**AGENDA  
OVERLAY DISTRICT BOARD  
JUNE 16, 2020**

**SUBJECT:** **Consideration of Four Alternative Standards Associated with a Proposed Expansion of an Existing Industrial Building on a 25.263-Acre Lot, Legally Described as Summit Business Park Addition, Block A, Lot 3; Located at 1175 North Stemmons Freeway; Zoned Light Industrial (LI) District, as Requested by Jason Russell of GSR Andrade Architects on Behalf of Norman International Dallas LLC, the Property Owner. (Case No. 20-05-5-ALTSTD)**

RE: Request for Alternative Standards to the IH-35 E Overlay District (**Revised**)  
Norman International Existing Facility  
1175 N Stemmons Freeway - Lewisville, TX

**ENGINEERING SITE PLAN**  
for  
Norman International  
25.263 Acres of Lot 3, Block A  
Summit Business Park  
City of Lewisville  
Denton County, Texas

### **EXISTING WEST WALL**

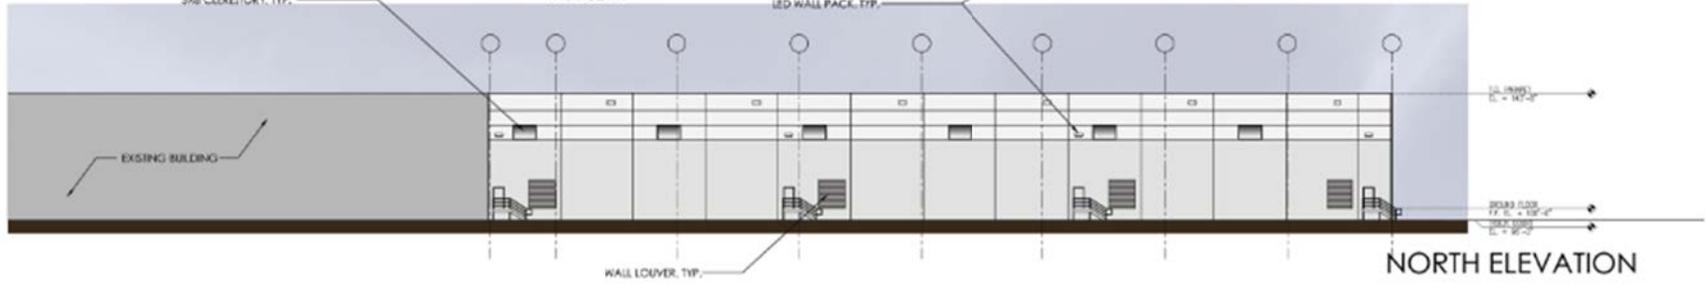
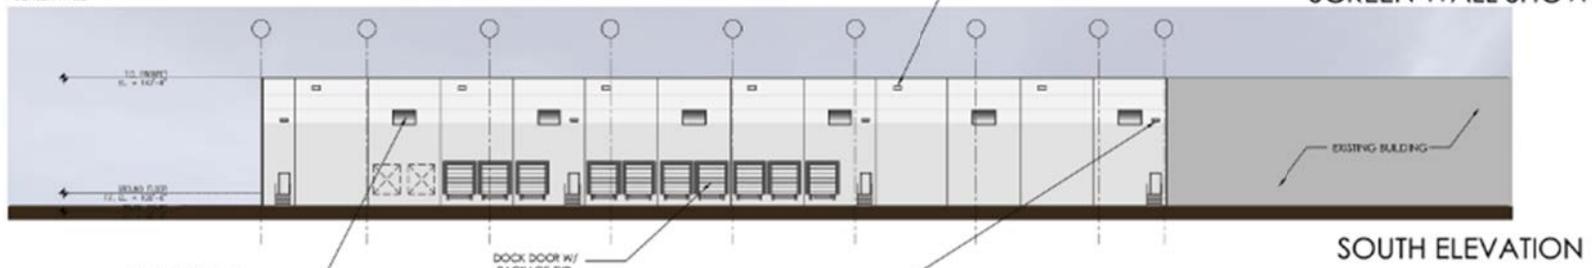
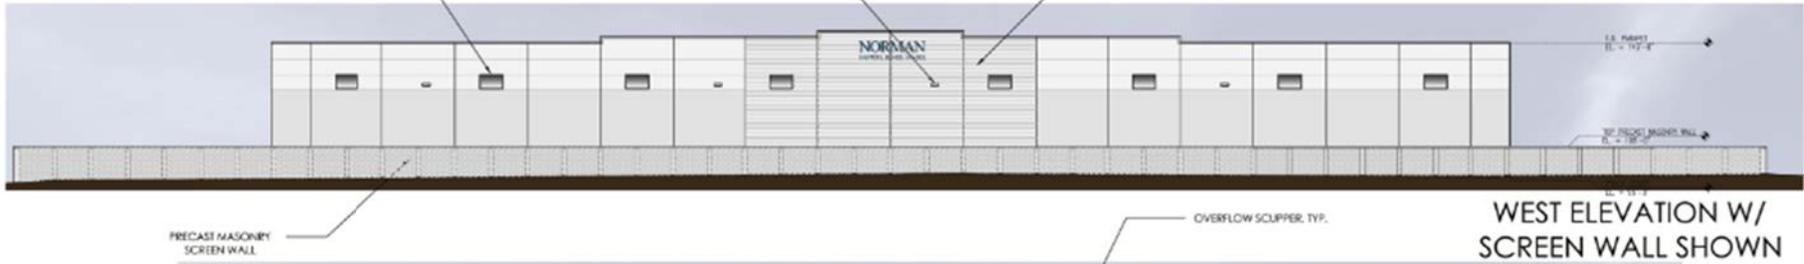
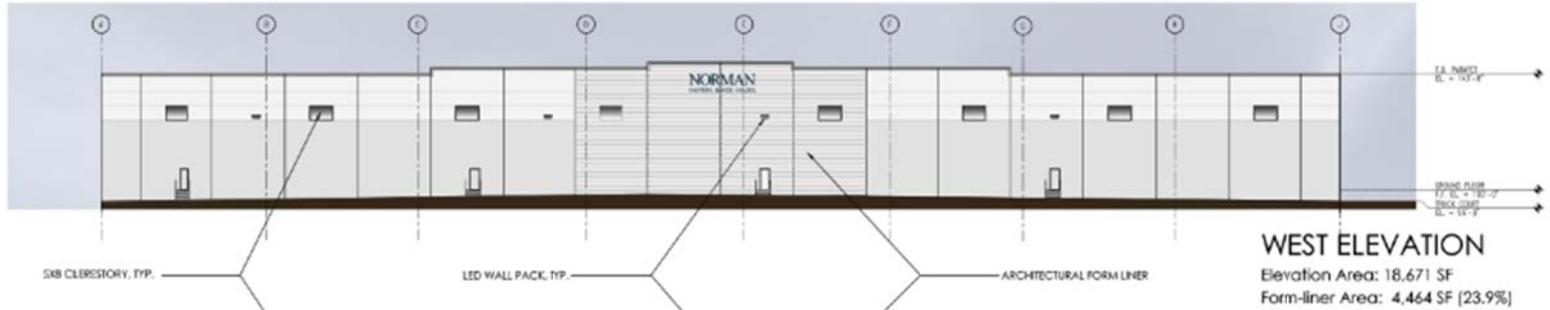
- c. An Alternative Standard is requested regarding articulation.

Section 17.5-5 (c)(1)a requires building facades visible from any street to demonstrate horizontal and vertical Articulation with Façade Rhythm between twenty to forty feet. The proposed tilt-wall consists of approximately 25-foot-wide bays where the rhythm is created with slits created during pouring of concrete and with difference in parapet height. All of the proposed colors are grey neutral colors as shown on the elevations and rendering. Staff is recommending approval with condition that additional vertical articulation is provided, reinforcing the 25-foot rhythm, through utilizing more slit lines and alternating proposed neutral colors. With this condition the project would meet the code requirement as the code allows for changing colors in combination with other techniques to meet the articulation requirements. The Overlay Board may make a recommendation to the City Council on this request.

2. An alternative standard is requested to Section 17.5-5 (c)(3) which requires 80% of each exterior wall to be comprised of brick or stone. We are requesting an alternative that the expansion to the building match the existing architectural tilt up concrete and reveal patterns ***with some added form-liner***. The only building façade that faces a public right of way will be the west façade. ***The form-liner will only be on the West elevation and will comprise 20% of said elevation. In addition***, the owner is proposing an 8'-10' tall precast masonry screen wall along the entire length of Summit Avenue parallel to the building expansion (as shown in the following Exhibit A Elevation). We request that the size and scale of the wall ***and the added form-liner*** be counted toward a reduced percentage of masonry requirement of 20% (on screen wall only) and that the cumulative visible surface area along Summit area include the west building face and screen wall.

3. An alternate standard to the horizontal articulation requirement. The intention is that the new west building façade will replicate the existing west wall and compliment the buildings existing architecture. The new west wall facing the public right of way will have the required vertical articulation as shown in Exhibit A Elevation.

That Overlay District Board recommend approval for Alternative Standards a) through c) as presented with the additional vertical articulation be provided on c) and consider alternative standard d) as presented.

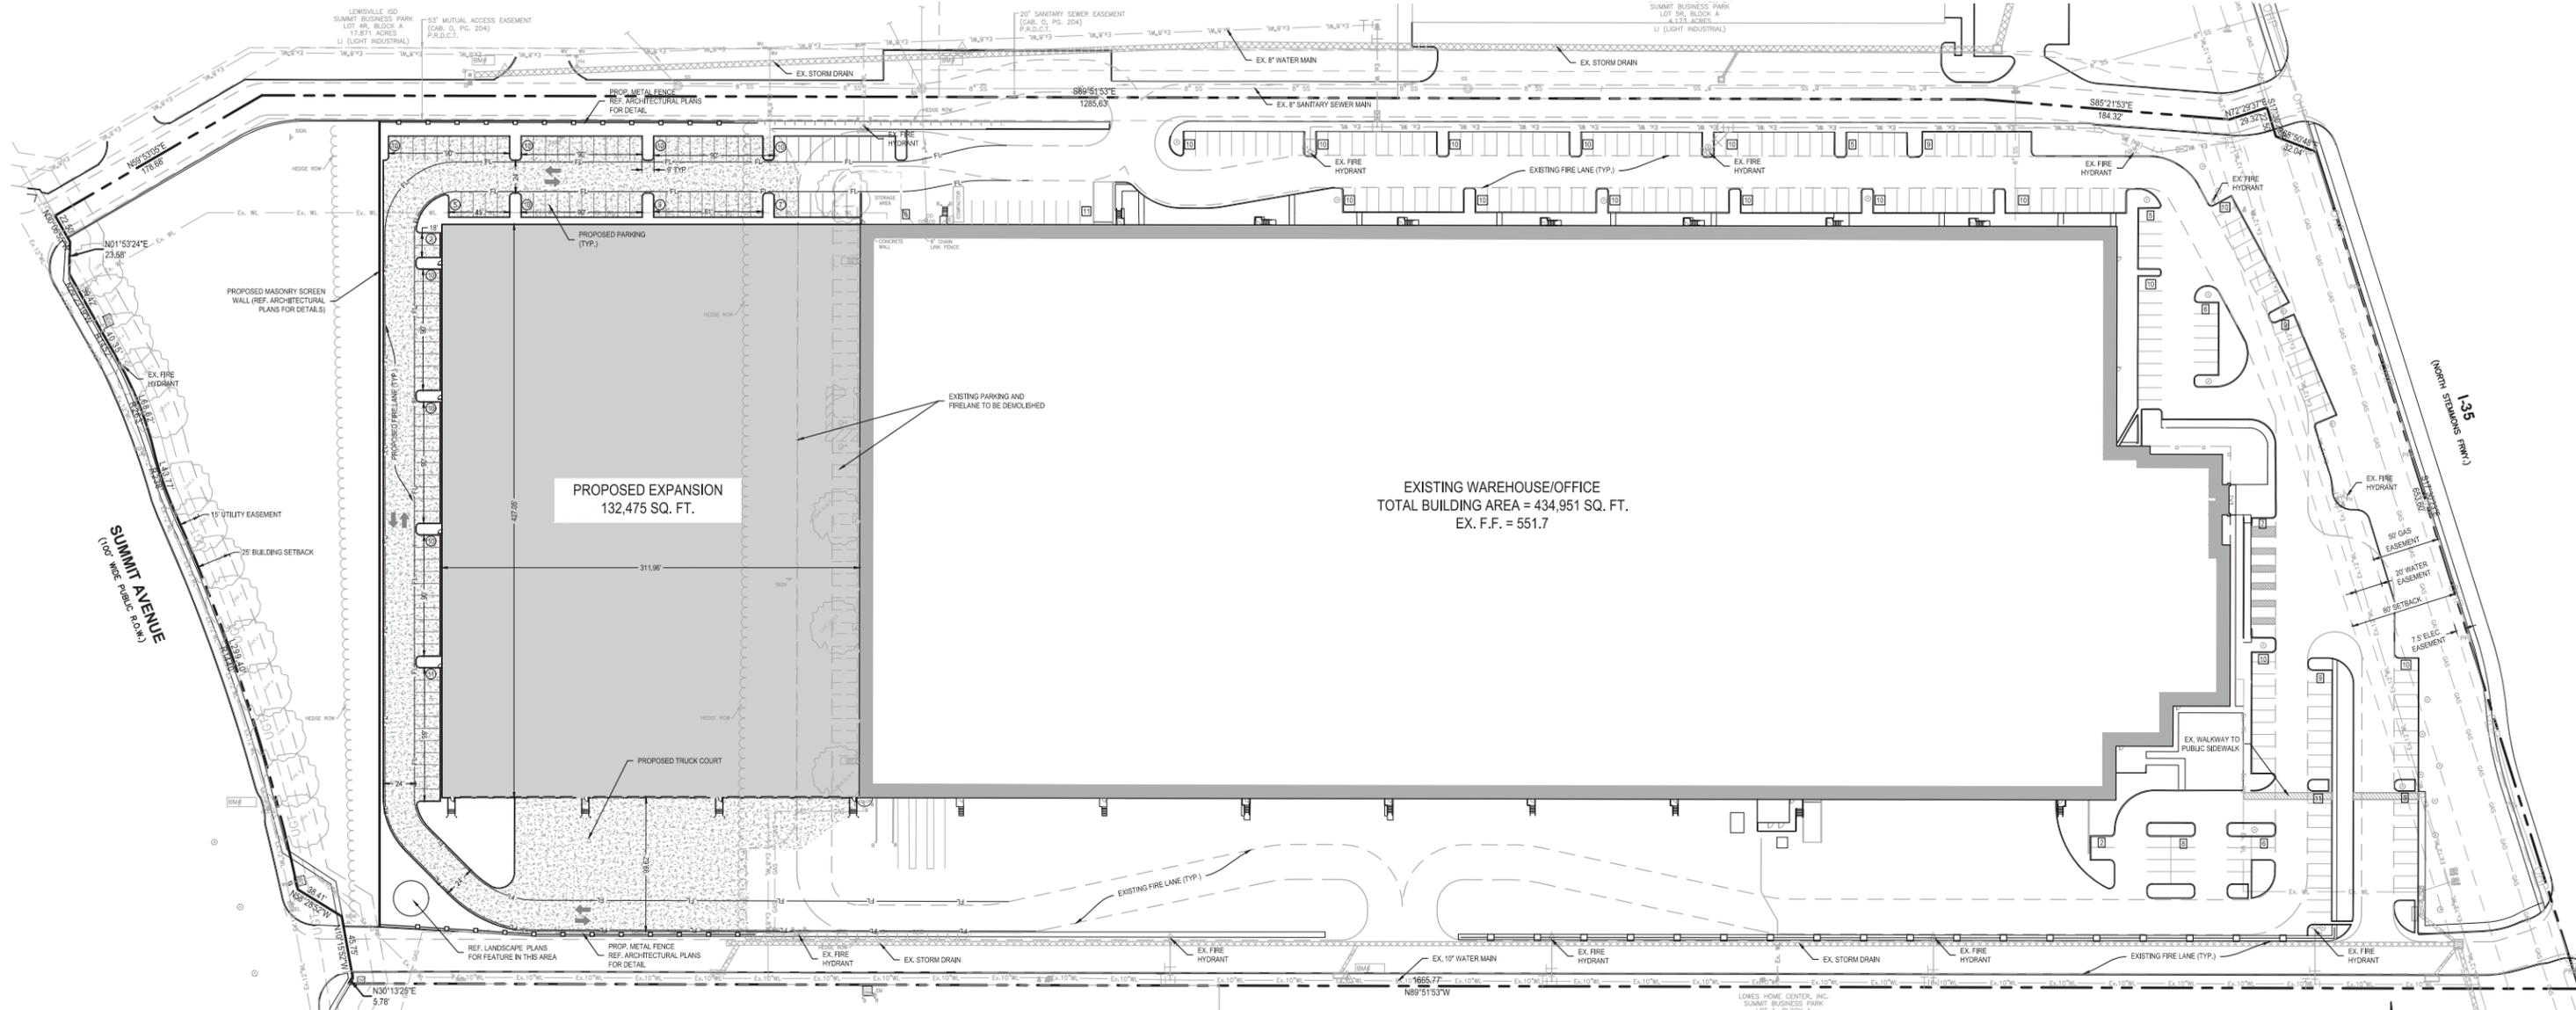
- a. The applicant is requesting an alternative standard to park the office portion at 1 space per 250 square feet and park the warehouse portion at 1 space per 2,000 square feet.

Section 17.5-5 (b)(7) requires one onsite parking space per 250 gross square feet of floor area. The applicant's proposal to park the warehouse area at 1 space per 2,000 square feet reflects the parking ratios for warehouses outside of the I-35E Overlay. The parking ratios established in the I-35E Overlay were adopted at a blended ratio anticipating mostly office, retail and restaurant developments. The goal was to reduce the parking standard and make reuse of the same site with a different use easier. No parking ratios were established for industrial uses. Staff is currently drafting revisions to the I-35E overlay to address proposed developments with industrial and office/warehouse buildings. Staff has no objection to this request. The Overlay Board may make a recommendation to the City Council on this request.

- d. The applicant is requesting an alternative standard to keep the existing sidewalk as is.

Section 17.5-4 (e)(4) & (5), Appendix F requires a 5-foot sidewalk along Summit Avenue. An Alternative Standard is requested to allow existing 4-foot sidewalk to remain, which is a 20% reduction from the requirement. The sidewalk is well maintained and in good condition. Trees are planted along the sidewalk on the property owner's side. The site is directly south of Lewisville High School Killough campus. The Trails master Plan calls for an enhanced sidewalk along Summit Avenue. The neighborhood directly opposite Summit Avenue has a 5-foot sidewalk. The Overlay Board may approve this request.

1. An alternative standard is requested to Section 17.5-5 (b)(7) which states that on-site parking shall be provided in a one space per 250 gross square feet of floor area. We are proposing meeting the 1: 250 sq. ft. ratio for the office area and meeting a 1:2000 sq. ft. ratio for the warehouse area, which matches the parking requirements for warehouse areas not within the overlay district. We request that you omit the parking requirement for 1:250 for the entire building and limit the requirement only to the office areas. ***In addition, it is our understanding that the existing parking to the East will be affected as part of the I-35 expansion. After discussion with the tenant, only a portion of the truck court will be used for distribution and any parking that is lost from the I-35 expansion can be recouped by striping the truck court if needed.***

4. *Section 17.5-5 (e)(3) &(5) requires a 5' sidewalk with a 4' amenity zone. Currently a 4' side walk already exists and is in good condition. Rather than demolish the existing concrete sidewalk and re-pour a new one, we request the existing 4' sidewalk remain in place.*
